**ADDENDUM 07 TO PLANS AND
CONTRACT DOCUMENTS**

**RIVERINE SAND MINING / SCOFIELD
ISLAND RESTORATION PROJECT (BA-40)**

PLAQUEMINES PARISH, LOUISIANA

ADDENDUM 07 TO BID DOCUMENTS
RIVERINE SAND MINING / SCOFIELD ISLAND RESTORATION PROJECT (BA-40)
FILE NUMBER: S28203DL

AREA OF ACQUISITION
BA-40 COASTAL RESTORATION PROJECT- SCOFIELD ISLAND
LOCATED IN PLAQUEMINES PARISH,
LOUISIANA

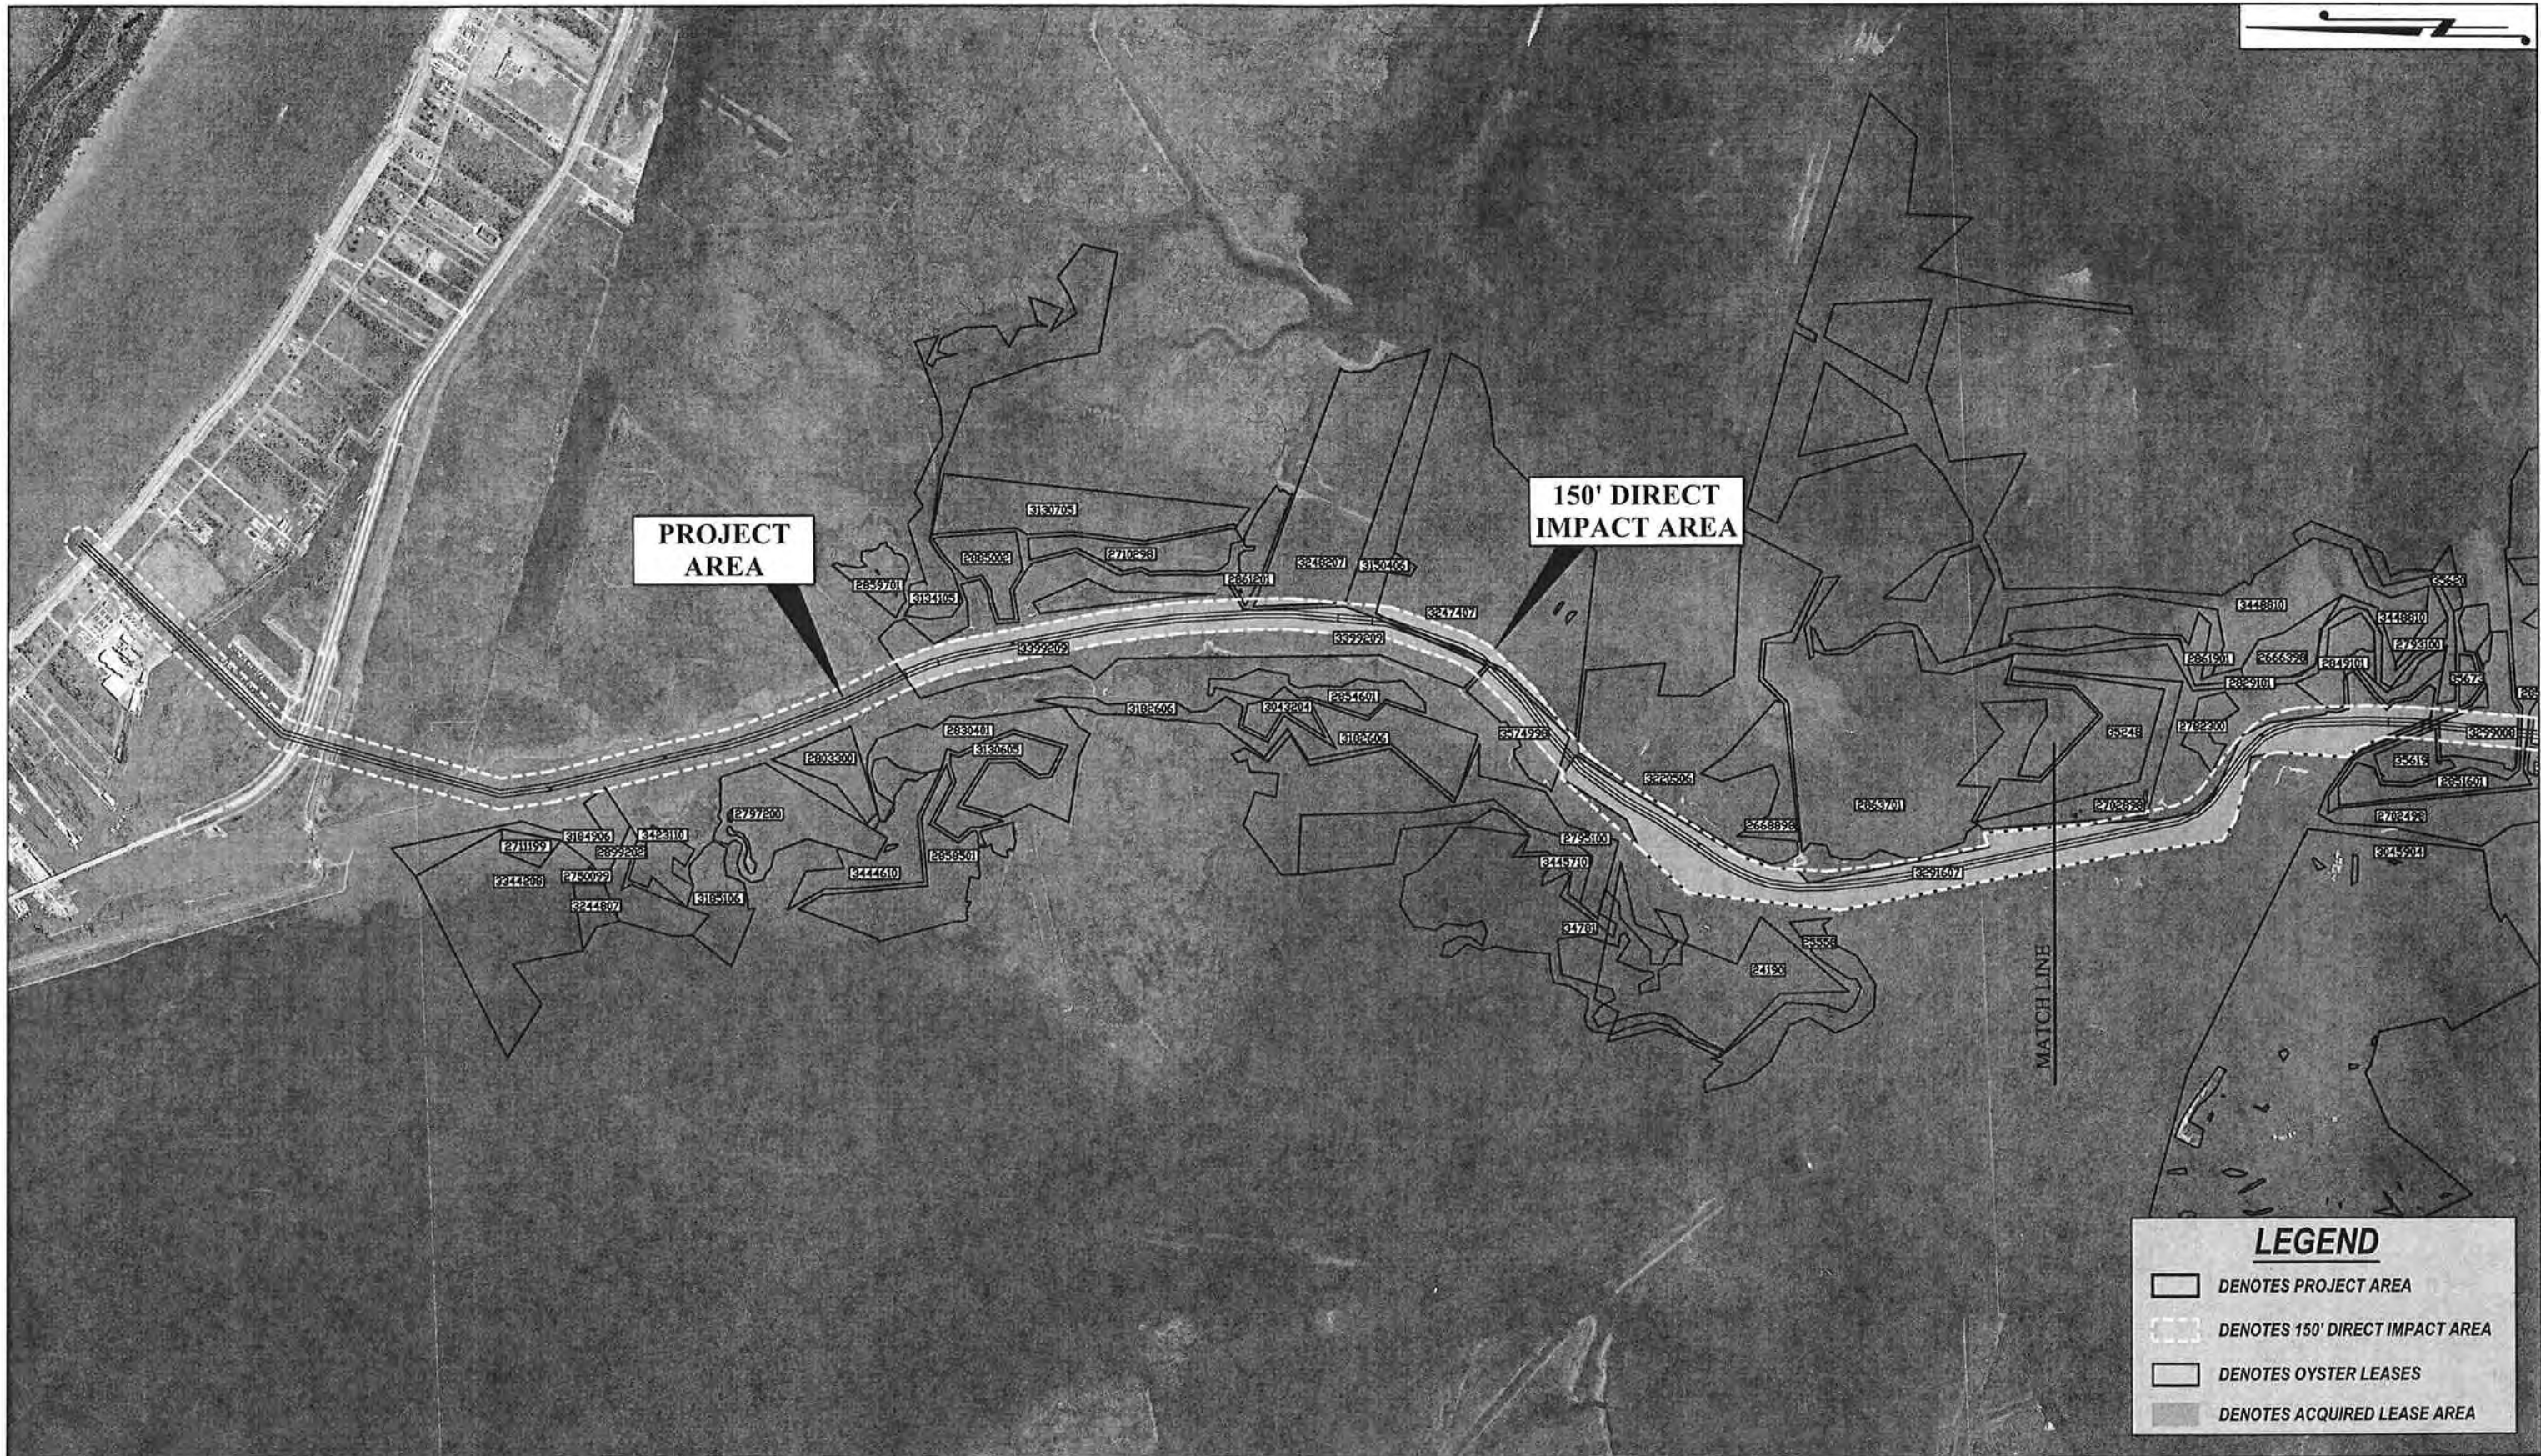
- 2.27 Question: Reference Special Provisions SP-23. The web site reference provided in this paragraph reveals active oyster leases exist within the limits of work throughout the project. A comment made at the pre-bid meeting indicated the State of Louisiana had purchased the oyster leases which would be impacted by the work. Please provide detailed information and drawings regarding the limits of oyster leases that have not been purchased by the State and their proximity to the limits of work for the Empire Waterway R/W, the Flotation Channel alignment, Work Area alignment, and the marsh and beach/dune fill areas.

Answer: Maps of limits of oyster leases acquired for the Project are included in Attachment B of this addendum.

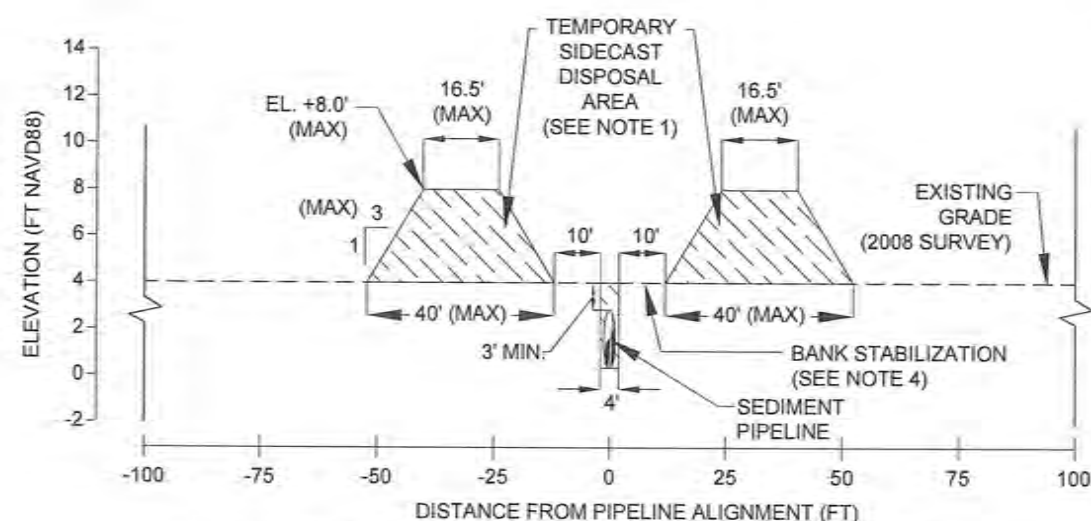
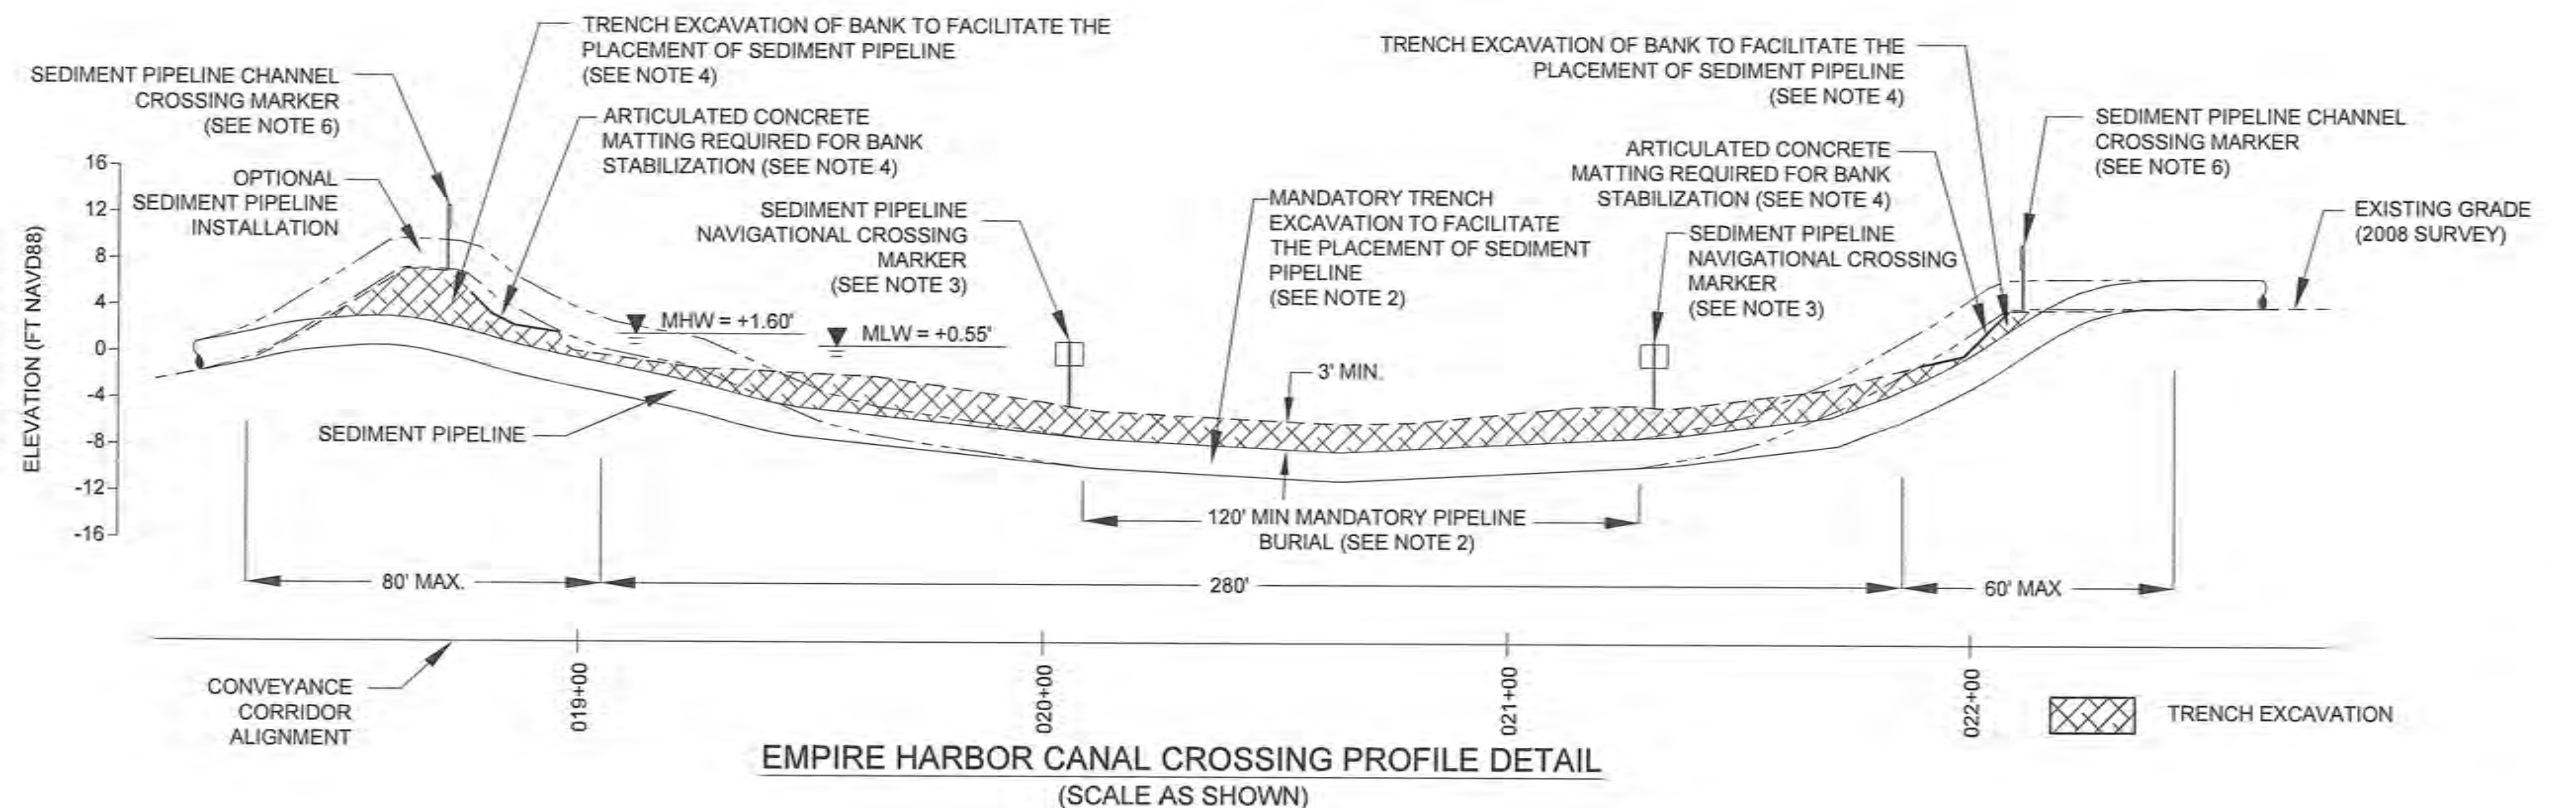
- 2.20 Question: Sheets 26 and 31's plan view call out "Earthen Fill with 7" Crushed Stone Top Side Slope = 1V:3H". Are the side slopes of the earthen ramps required to be covered with 7" of crushed stone or just the 10' wide temporary road surface?

- 2.21 Question: Regarding the temporary gravel road shown on plan sheets 26 and 31, will recycled crushed concrete or recycled asphalt be allowed in lieu of crushed stone?

Answer: Slopes of the earthen fill are not required to be covered with road surface material. Refer to response to Question 2.21 for further information on road bed construction materials. Refer to revised Specification TS-10 CONVEYANCE CORRIDOR, 10.4.4.1 Mississippi River and Hurricane Protection Levee Crossing regarding fertilization and seeding of earthen material and revised Plans Sheets 26, 31, and 32 of Sections 3 and 4, respectively, of this Addendum.

Answer: Yes. Refer to revised Specification TS-10 CONVEYANCE CORRIDOR, 10.4.4.1 Mississippi River and Hurricane Protection Levee Crossing in Section 3 of this Addendum.

EMPIRE HARBOR CANAL BANK STABILIZATION
PROFILE TYPICAL DETAILS
 (SCALE AS SHOWN)

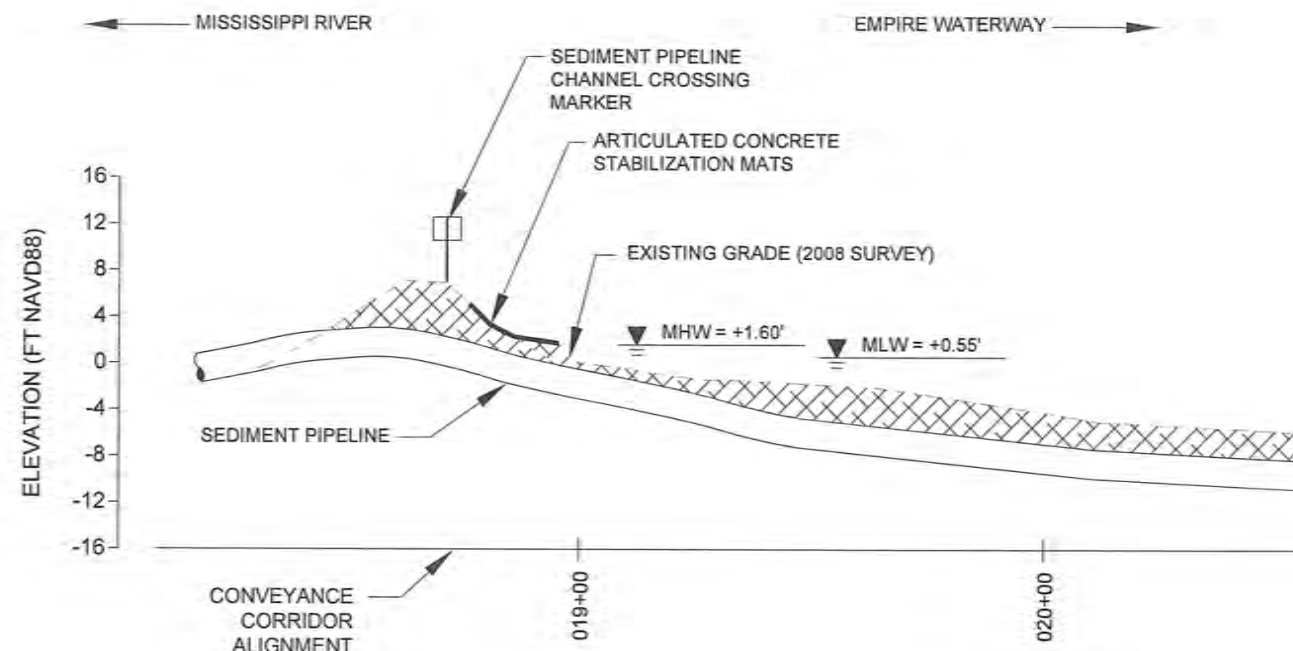
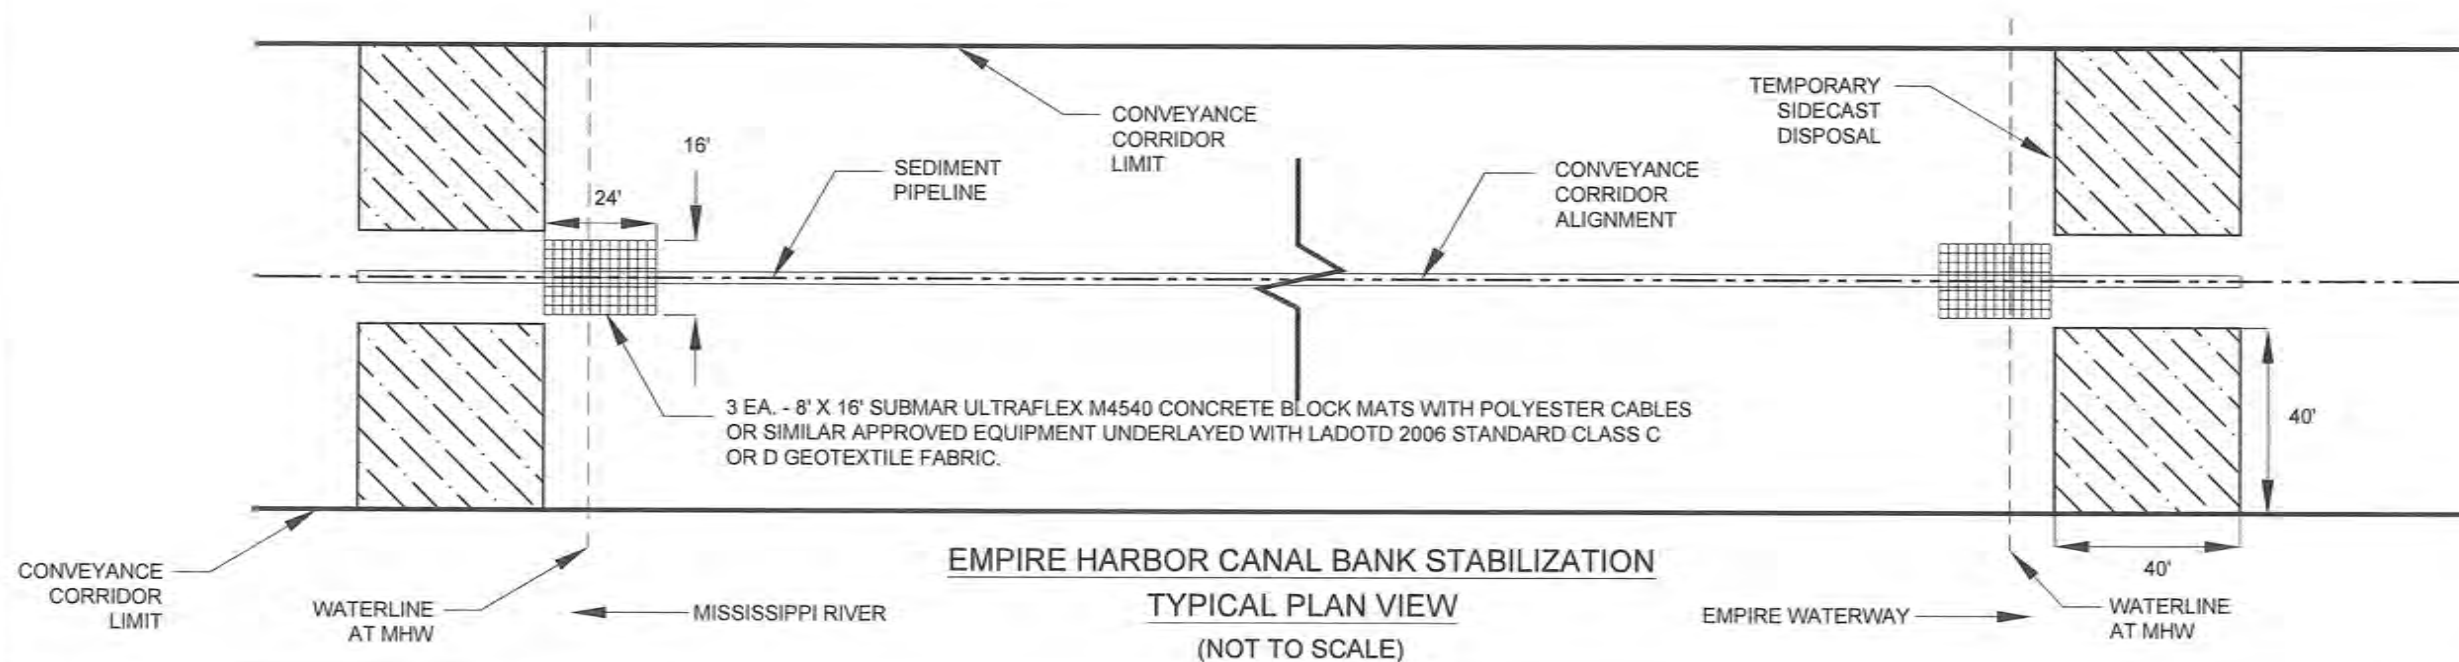
- 2.38 Question: Reference Technical Specifications TS-10.4.4.3. The follow-up to the discussions during the site visit, please specify the minimum depth and width required for navigation in the Empire Harbor Canal.

Answer: Refer to revised Specification TS-10 CONVEYANCE CORRIDOR, 10.4.4.3 Empire Harbor Canal Crossing and revised Plan Sheet 28 in Section 3 and 4, respectively, of this Addendum.

SHEET 37 OF 57

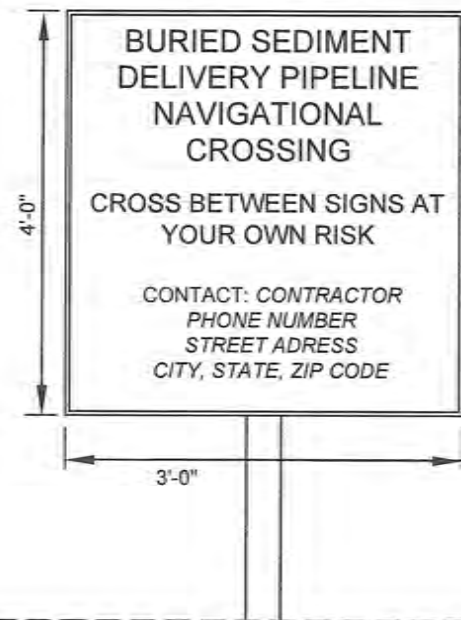
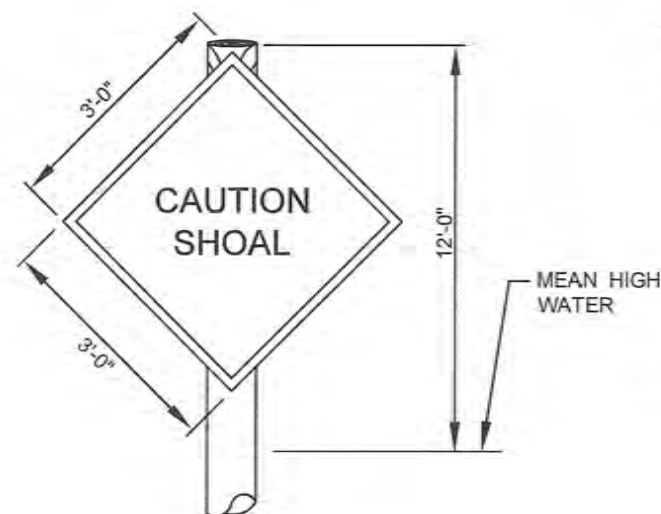
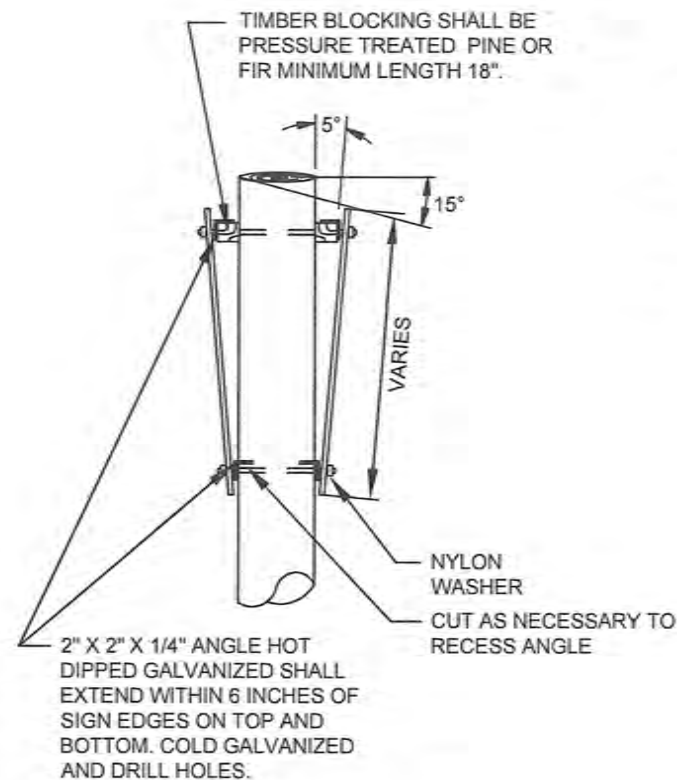
- 2.13 Question: Regarding the Sediment Pipeline Markers on Plan Sheets 36 & 37, please provide the minimum dimensions for these signs.

- 2.15 Question: Are 1 EA or 2 EA signs required per Navigational Marker sign pile?

Answer: Refer to revised Specification TS-9 DREDGING AND SEDIMENT PIPELINE LIGHTED AIDS AND MARKING, 9.4.3 Sediment Pipeline Channel Crossing Markers, 9.4.4 Sediment Pipeline Navigational Crossing Markers, and revised Plan Sheet 37 in Section 3 and Section 4, respectively, of this Addendum.

Answer: Two signs shall be required per pile for Navigational and Sediment Pipeline Navigational Crossing Markers. One sign per pile is required for Shoal Signs and one sign per pile set is required for Sediment Pipeline Channel Crossing Marker. Refer to revised Plan Sheet 37 in Section 4 of this Addendum.
